OHIO PAPERBOARD

April 28, 2010

**Re: Ohio Paperboard / Fairfield County
Industrial Storm Water Permit 4GR00120*DG**

Ohio Paperboard
Unlabeled drum w/o secondary
containment near drain to
WWTP
Walnut Creek Watershed
April 21, 2010
Photo by: Greg Sanders

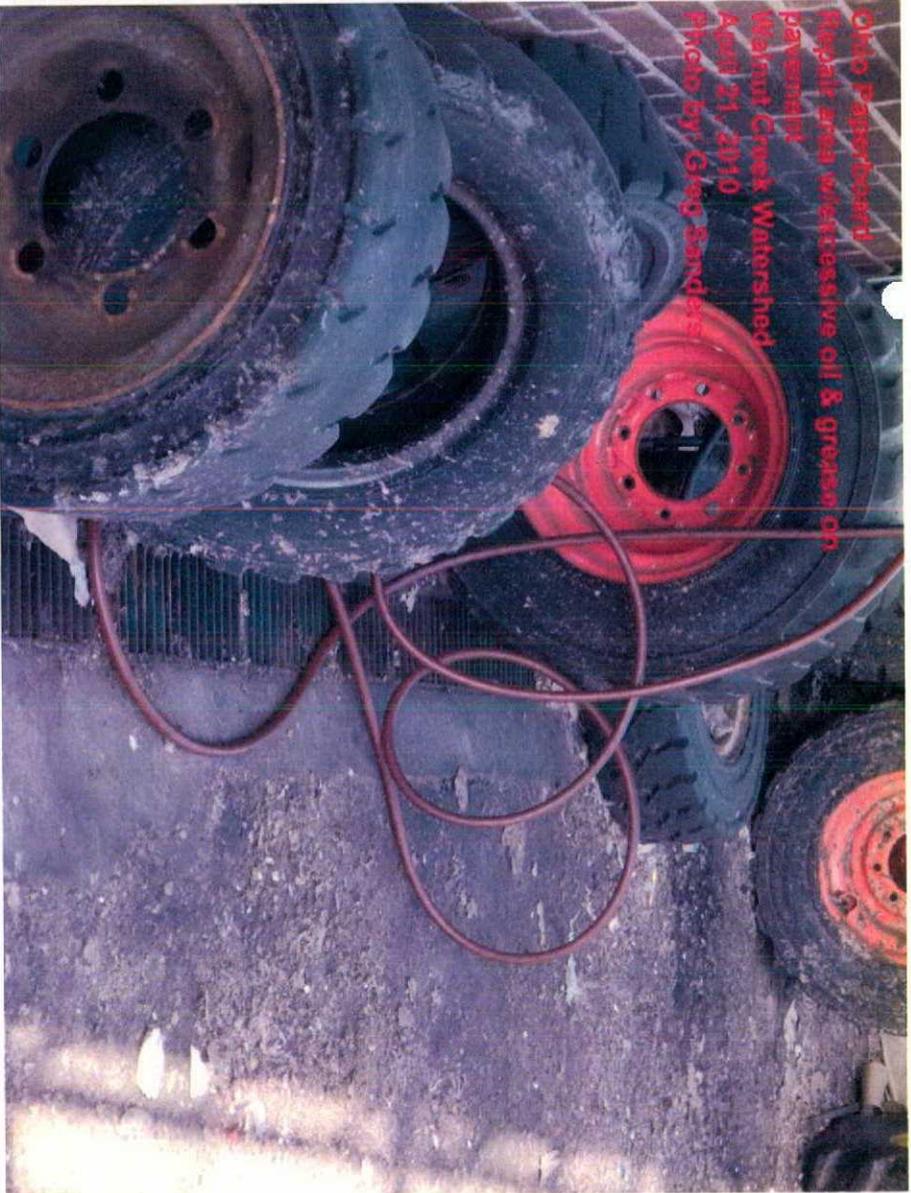
1. Your company had a storm water pollution prevention plan (SWP3) and a spill prevention plan at the facility. The plans were reviewed annually or after a change in staff.
2. Unloading is done in a contained area. Most of the unloading areas have secondary containment and under roof.
3. There were several drums stored outside. The drums need to be labeled. The drums either need to be stored inside the building or they need to be stored with lids and in secondary containment.
4. A map of your storm water discharge points were provided to me. It is recommended that the outfall that serves the main part of the outside production area have a gate valve. The gate valve could be closed in the event of a spill.

Ohio Paperboard
Fueling station - excessive fuel on
ground with discharge to WATP
Walnut Creek Watershed
April 21, 2010
Photo by: Greg Sanders

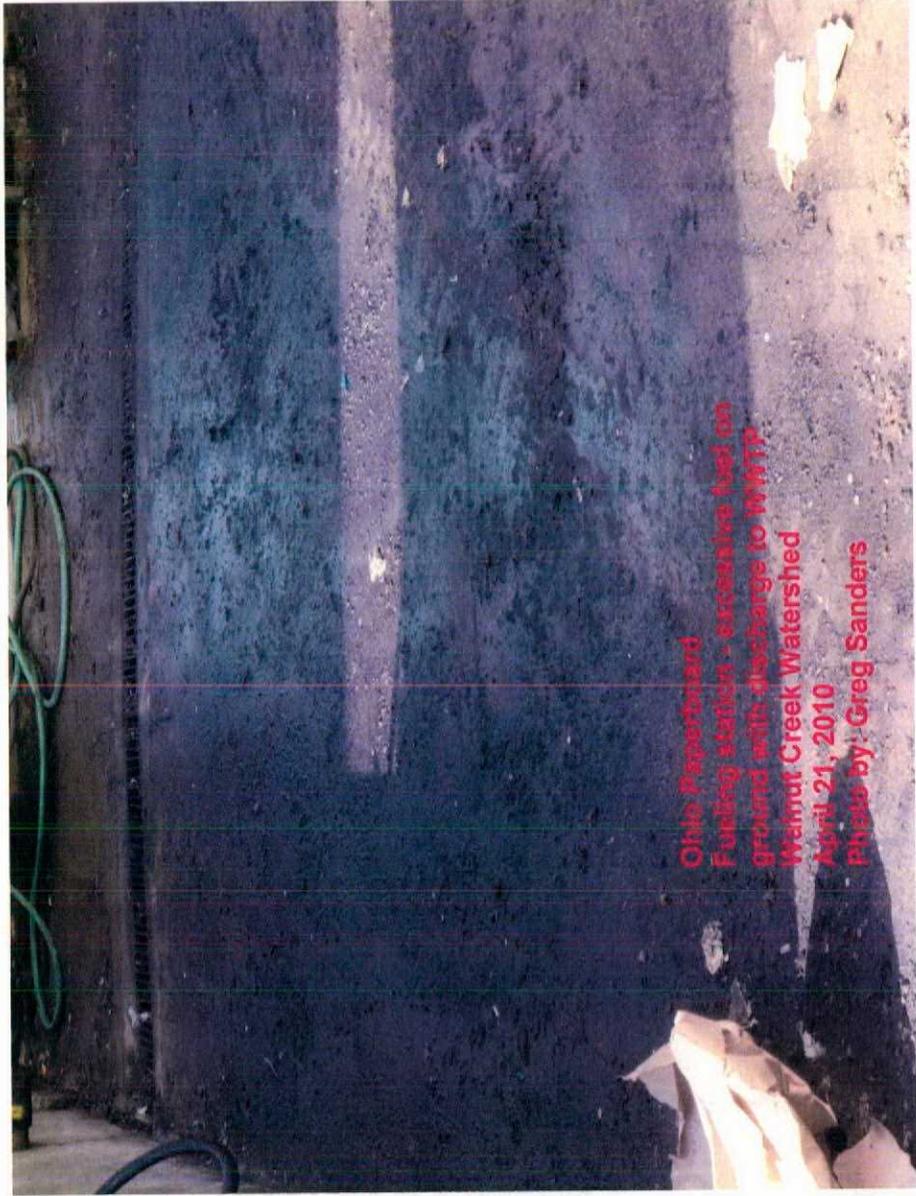
7. Housekeeping in the fueling area was poor. A lot of fuel was spilled on the ground and could discharge to drains which discharge to the WWTP. Excessive fuel could upset the WWTP and prevent it from properly treating its wastewater. It is requested that the fueling area be in a secondary containment area and the captured wastewater be discharged to an oil-water separator before discharging to the WWTP. This area should be put under roof to prevent excessive storm water to the oil-water separator. Also, the SWP3 and spill prevention plan should be revised to include this secondary containment. Please see attached picture.
